BMP NUMBER: CC015

RECORD DRAWING
OF
STORMWATER POND NO. 1
ANHEUSER BUSCH BREWERY
TRANSPORTATION ADVANTAGE PH. II

The Environmental Division has reviewed record drawings and construction certifications as submitted to our office on February 14th 2001 for the above referenced facilities. The items submitted provide as-built information for the wet ponds and their associated storm drainage systems, which are situated in the southwest corner of brewery Parcel D-2.

Re: Response to Letter
of March 01, 2001

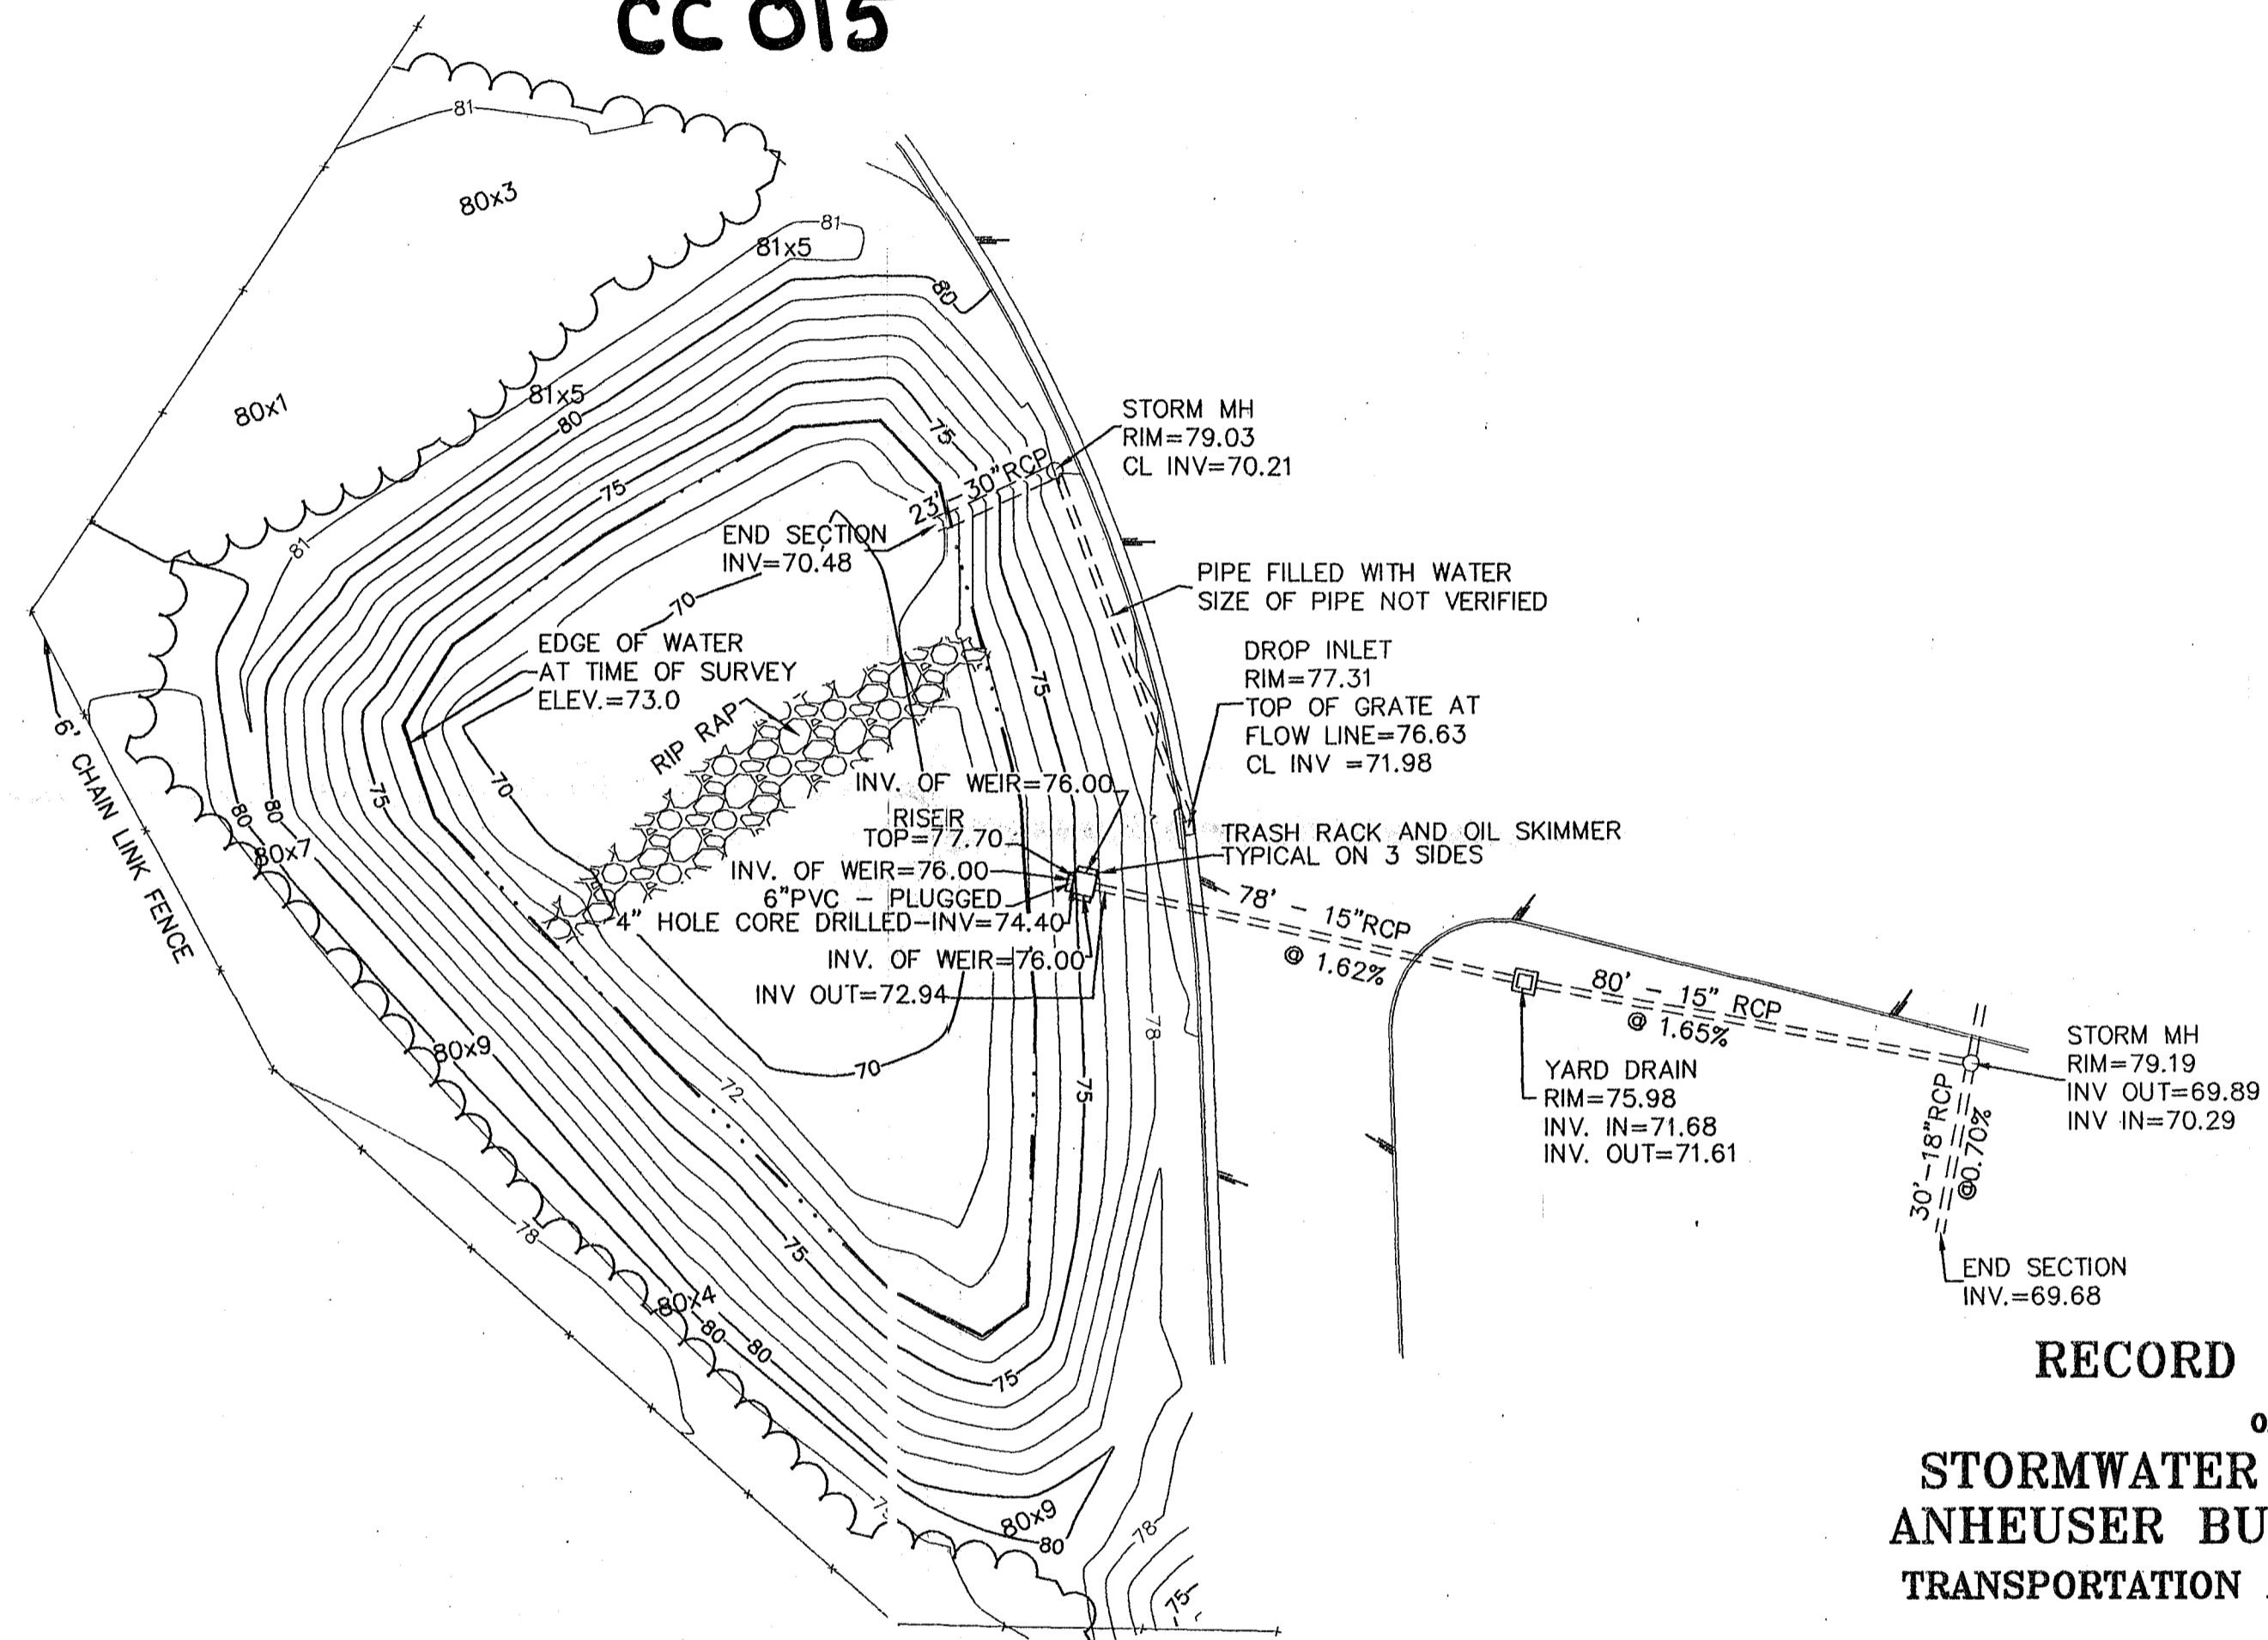
1. Add the control structure detail from Sheet 207 of the approved design plan, annotated as necessary to show as-built conditions, to the record drawing. This detail shows specific information relative to principal control structure CS-1.
2. Include the maintenance plan, taken from the approved plan on the record drawing.
3. If possible, add the following County identifiers to the lower right hand corner of the record drawing sheet: County Plan Number SP-121-99 and BMP ID No. CC 015.

4. Clean and remove all debris in the vicinity of the riser (PVC pipe, wood, etc.) and seed and mulch bare soil areas directly around the riser

6. Restore the riprap outlet protection at the outfall end of the Pond 1 barrel at drainage structure ST-11. The outlet protection should be restored to the size and dimensions per approved plan Sheet 215 and be at level grade.

7. Ensure the pond riser is at its final design plan configuration, especially related to the 3-13/16" center drilled low flow orifice.
8. There is an area of impounded drainage along the west side the access road just south of Pond 1. Install a small diameter drain to properly convey this drainage to Pond 1. It is our understanding that this issue was raised and was supposed to be taken care of during construction.

COMMENT 1: Add the control structure detail from Sheet 207 of the approved design plan, annotated as necessary to show as-built conditions, to the record drawing. This detail shows specific information relative to principal control structure CS-1.

COMMENT 2: Include the maintenance plan, taken from the approved plan on the record drawing.

COMMENT 3: If possible, add the following County identifiers to the lower right hand corner of the record drawing sheet: County Plan Number SP-121-99 and BMP ID No. CC 015.

COMMENT 8: There is an area of impounded drainage along the west side of the access road just south of Pond 1. Install a small diameter drain to properly convey this drainage to Pond 1. It is our understanding that this issue was raised and was supposed to be taken care of during construction.

REVISED 03/13/01 PER JAMES CITY COUNTY COMMENTS

RESPONSE: *Not within scope of requirements. Construction drawings include details necessary for constructability. This level of detail is not necessary for, nor required for record drawings.*

RESPONSE: *Not within scope of requirements. Plan was previously provided with the permit application.*

RESPONSE: *The information has been added.*

RESPONSE: *A drainpipe cannot be installed at this location. Doing so would introduce storm water into the clean side of the pond. All inlets are above the forebay baffle. It is intended that this shoulder run-off be introduced into the gutter flow and collected at Inlet ST-9.*
